Amendments to the Drawings:

REMARKS

Thelen Reid & Priest – Robert E. Krebs
Serial No. 09/510,349
Filing Date: February 22, 2000
TRP Docket No.: 034620-049

FIG. 19
PRIOR ART

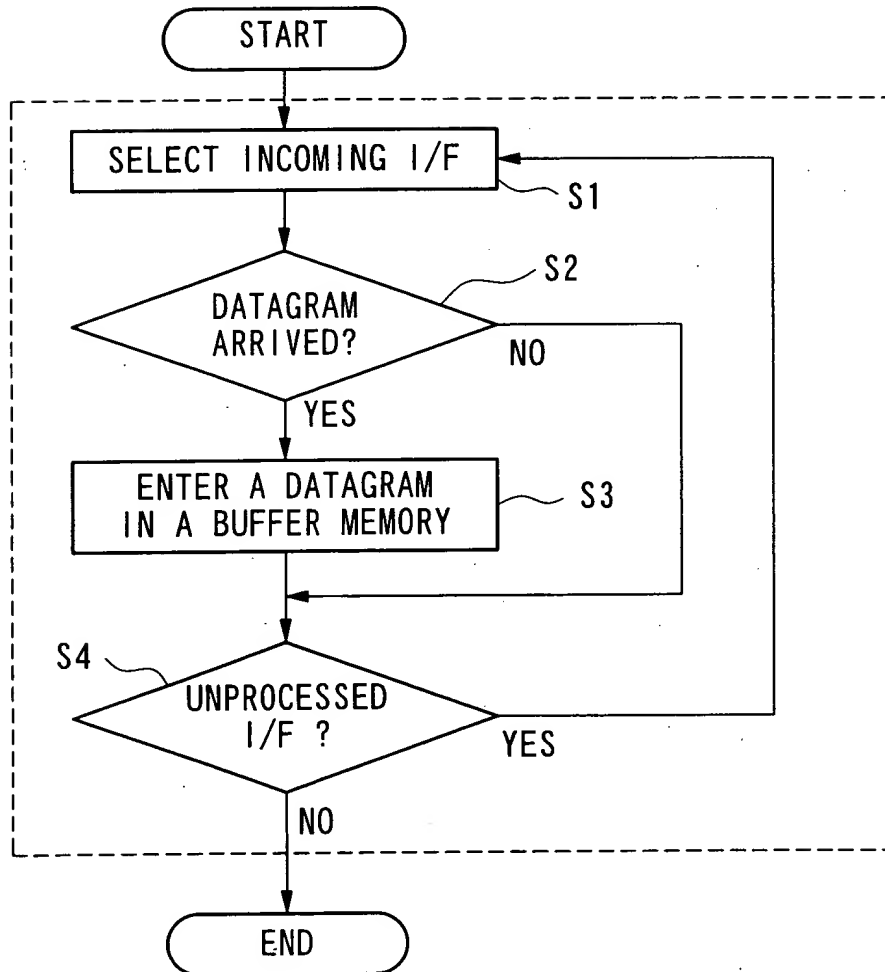
The attached replacement and annotated sheet(s) of drawings includes changes to FIGS. 19-23 as follows.

FIGS. 19-23 have been amended to include the legend -- Prior Art --.

The figures stand objected to because "Figures 19-23 should be designated by a legend such as -- Prior Art --". Figures 19-23 have been amended to include the legend. It is respectfully requested that this objection be withdrawn.
